**WESTERN SYDNEY AIRPORT BUSINESS PARK  
(SSD-64409468)**

**SUBMISSION BY ANTHONY KRILICH**

**KRILICH – LOT 1 DP 220176 (NO. 2600) ELIZABETH DRIVE  
LUDDENHAM NSW 2745**

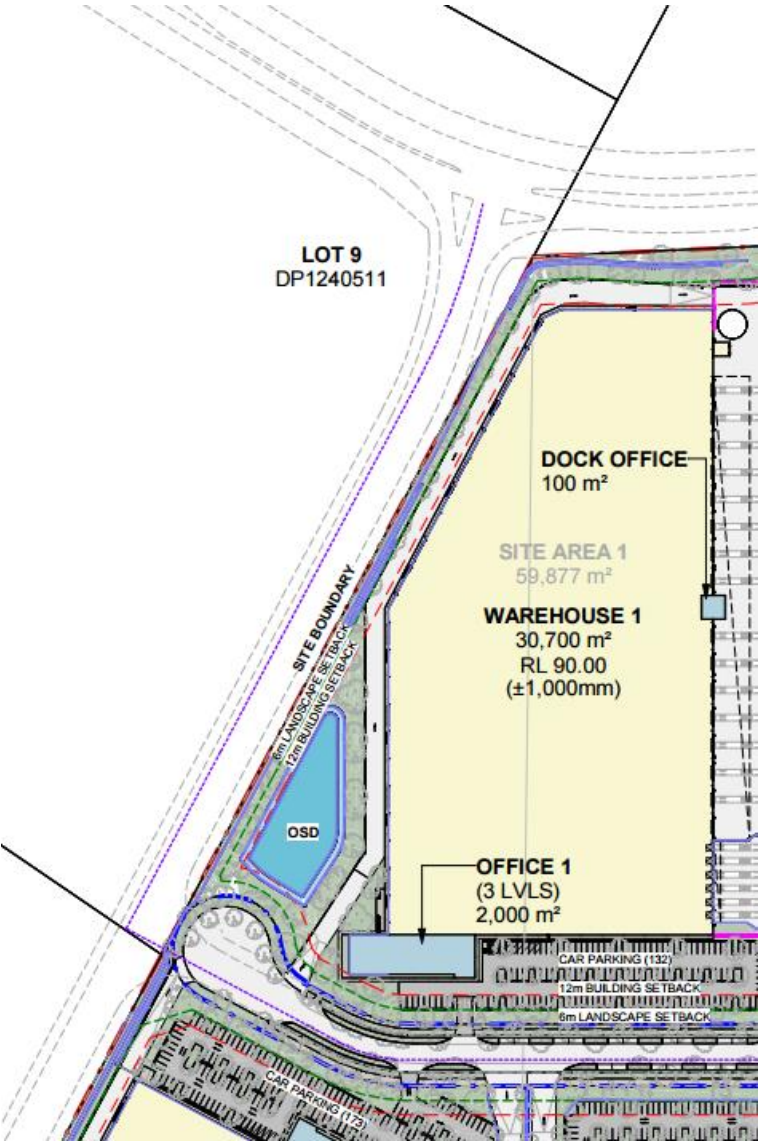
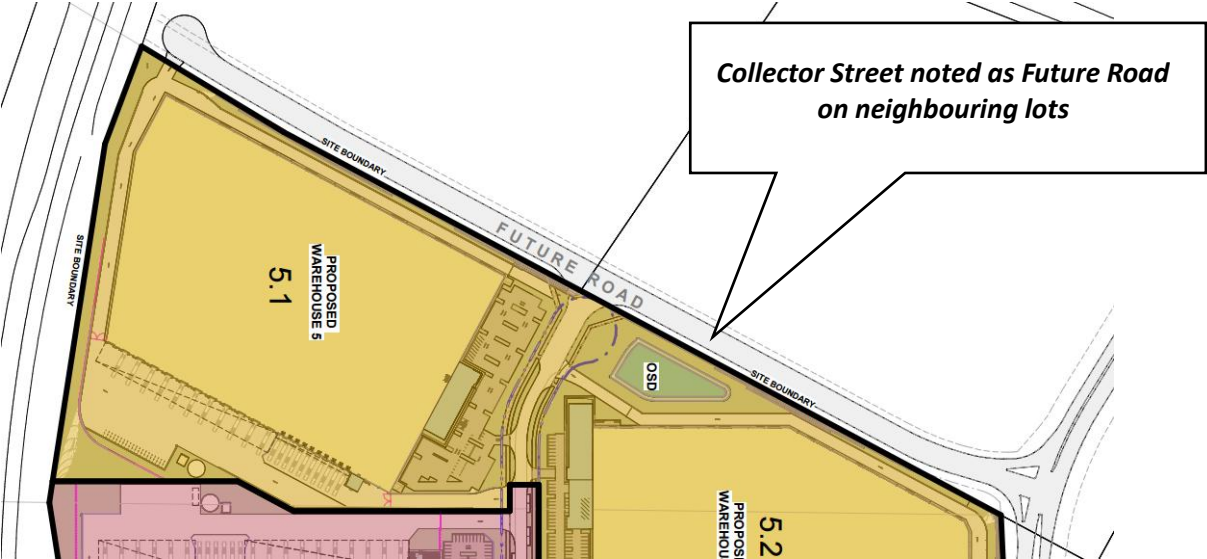
The proponent has shown a road network that is not consistent with the Precinct Plan. In particular the **Collector Street** shown on neighbouring Lots 8 and 9 in DP1240511 is in a location that is not consistent with the Precinct Plan.

This road is shown wholly on neighbouring lots and also in a location that is off the common boundaries with the development site.

The alignment of this road affects other lots within the locality including our property. Its location sets a precedence for the remainder of the Transport Network within the Agribusiness Precinct, and it needs to be correctly approved in a location that is consistent with the Precinct Plan.

The development application needs to be amended or modified to show this Collector Street in an area that is equally shared, and is to be equally built between the subject site and neighbouring lots on a 50:50 basis. Its proposed location affects development on neighbouring lots and the development potential of these lots and other lots in the area.

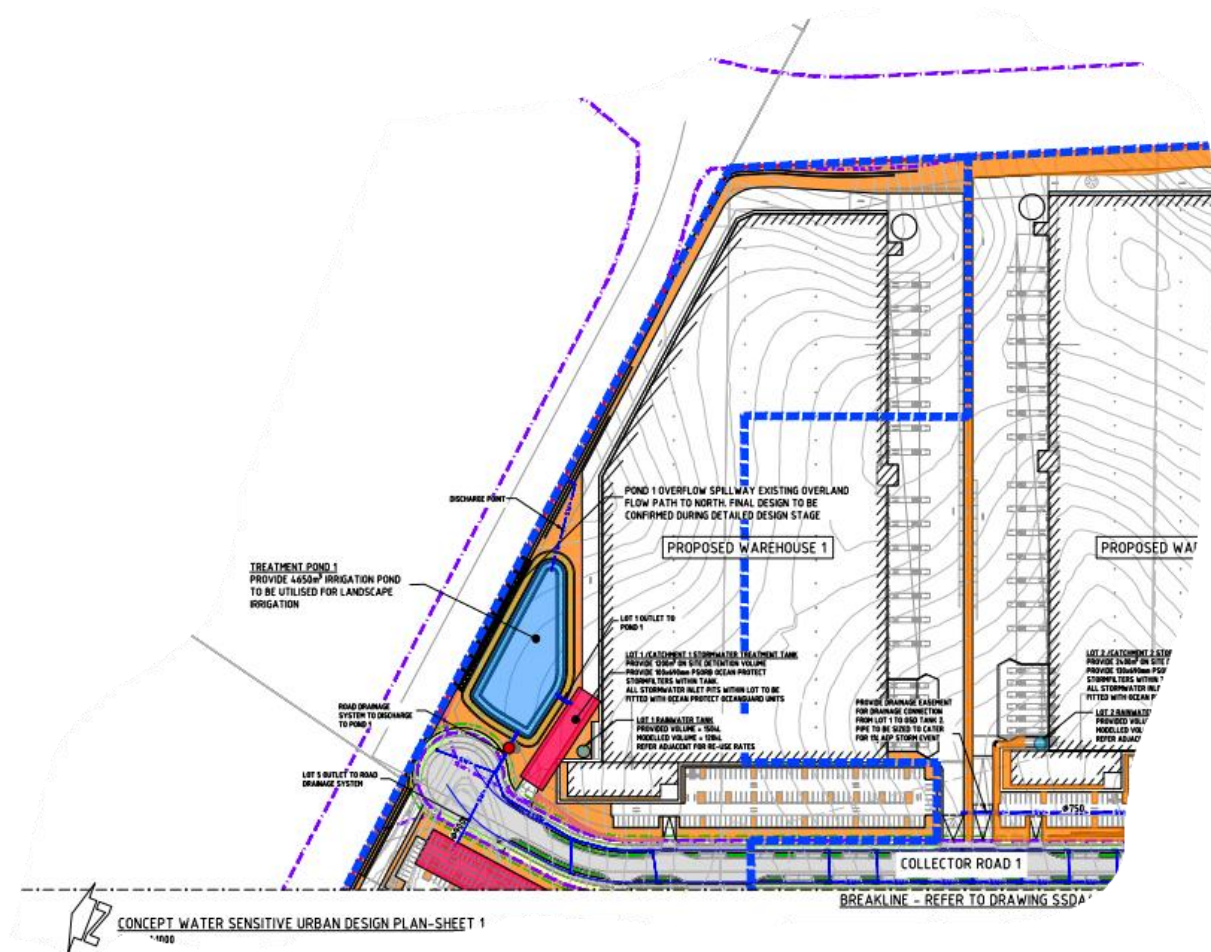
The proponent's variation to the Collector Street location also impacts on the delivery of stormwater drainage to the northern part of the development.

How will this part of the site convey stormwater to the Total Water Cycle Management network if relying on a Collector Street (and its associated drainage) built on neighbouring land?

The northern part of the development which drains onto the two adjoining lots to the north therefore relies on stormwater drainage in this Collector Street to be built for it to be viable. Requirement SH2f is therefore not complied with.

**Figure 22 – Liverpool Land Acquisition Plan**

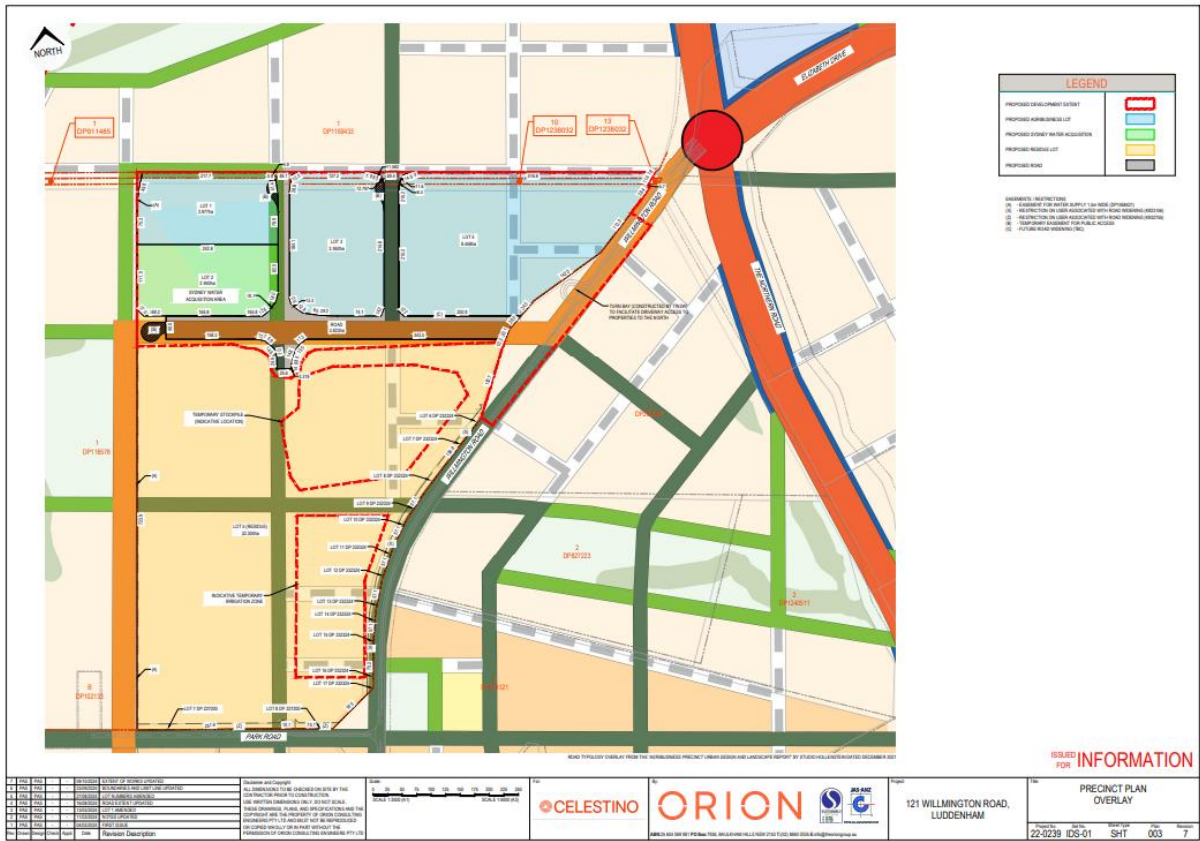
Anton Road North, being a sub-arterial road on the eastern boundary of the subject site, is funded and land is to be acquired for this road via the Section 7.12 Plan. This is shown below:

The east-west Collector Street in question under this submission is not funded by these contribution plans and is to be **funded and built by developers**. So who will pay for this? Will there be a mechanism to pay for this, such as via a Voluntary Planning Agreement? Will the developer be required to fund and build this Collector Street?

Figure 4.4: Zoning Plan (Source: Western Parkland City SEPP)

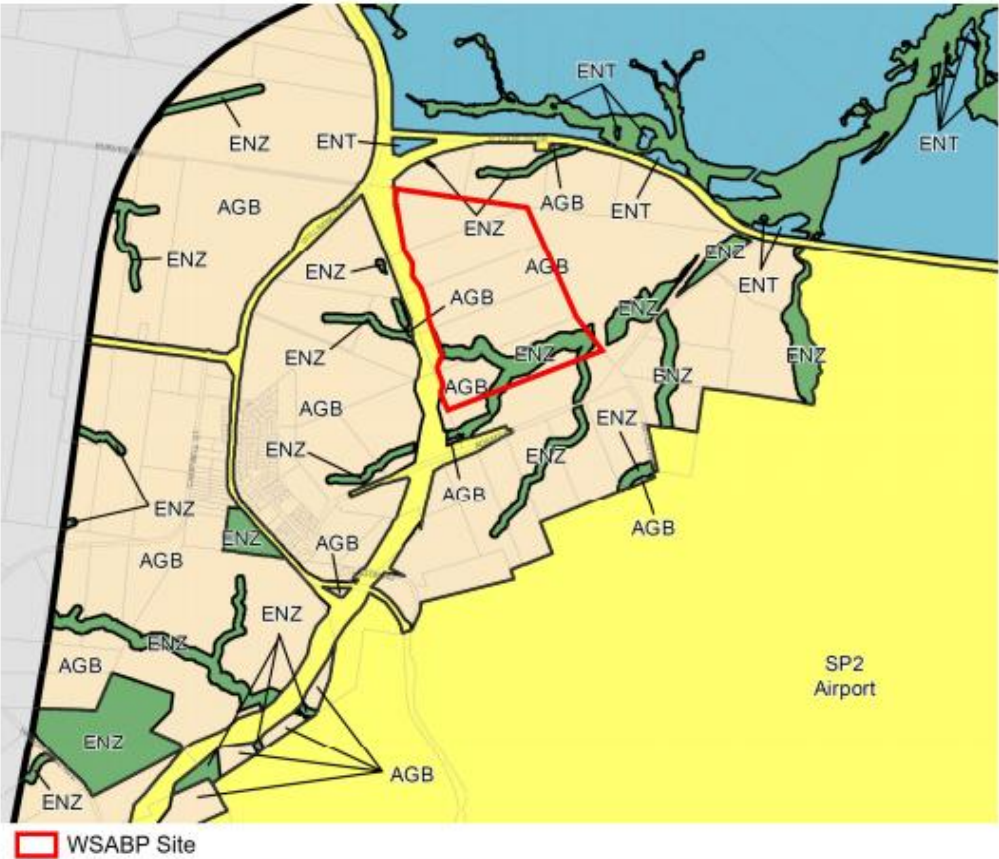
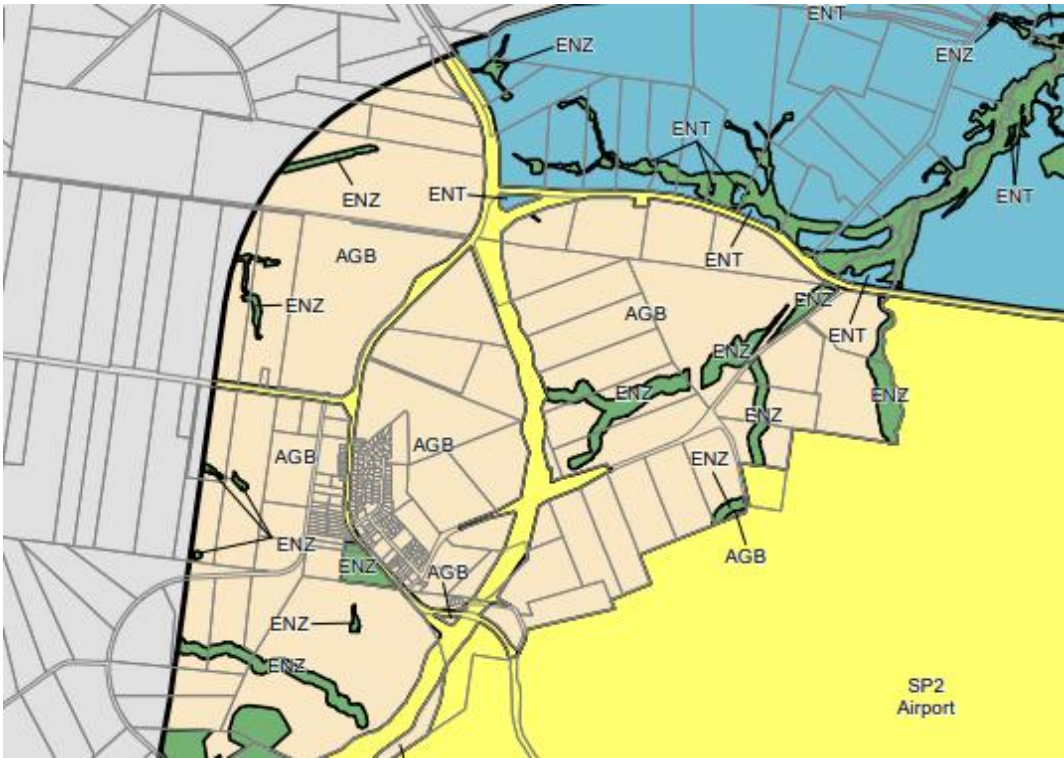
The EIS incorrectly identifies the zoning map that applies to the site and surrounds. An extract of the EIS zoning map is shown below in comparison with the current zoning map, which has applied for some time now since 17 August 2022 (the ENZ was been removed from surrounding sites two years ago).

Zoning plan is incorrect and needs to reference correct zoning map (since 2022) is shown below
